Template for submitting proposals related to GHG Protocol's *Corporate Standard*, *Scope 2 Guidance*, *Scope 3 Standard*, *Scope 3 Calculation Guidance* and market-based accounting approaches

Treatment of biogenic and bioenergy emissions

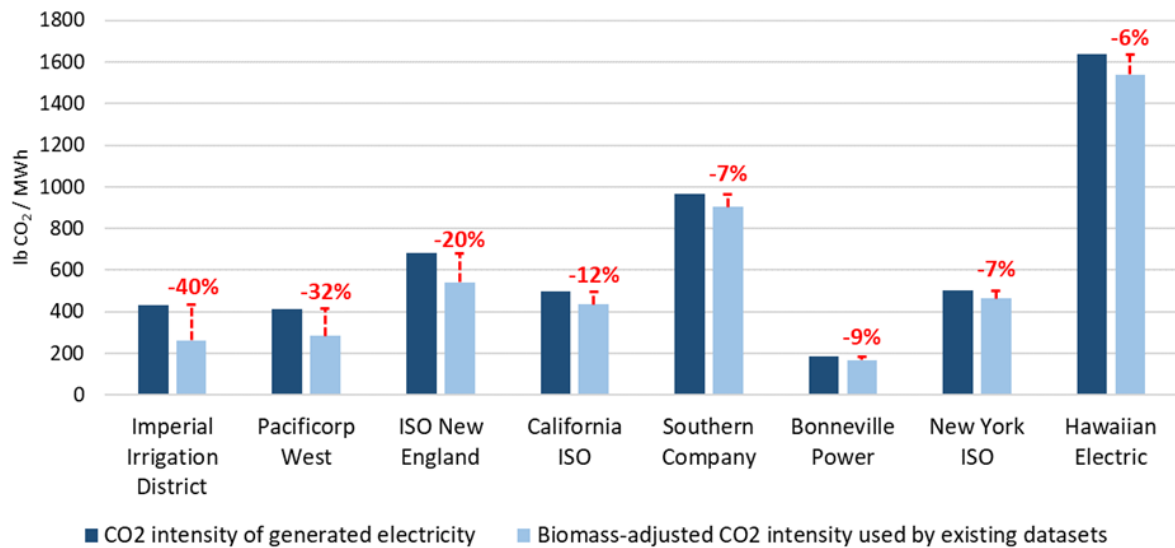
Upcoming research by Miller et al. titled “Evaluating the hourly emissions intensity of the US electricity system,” examined the effect of treating bioenergy as zero-carbon when calculating location-based emission factors for the U.S. This research found that this exclusion underestimates direct CO₂ emissions from electricity generation in the U.S. by 3% nationally and leads to substantial under-representations of power sector emissions in some of the largest grid regions in the U.S.:
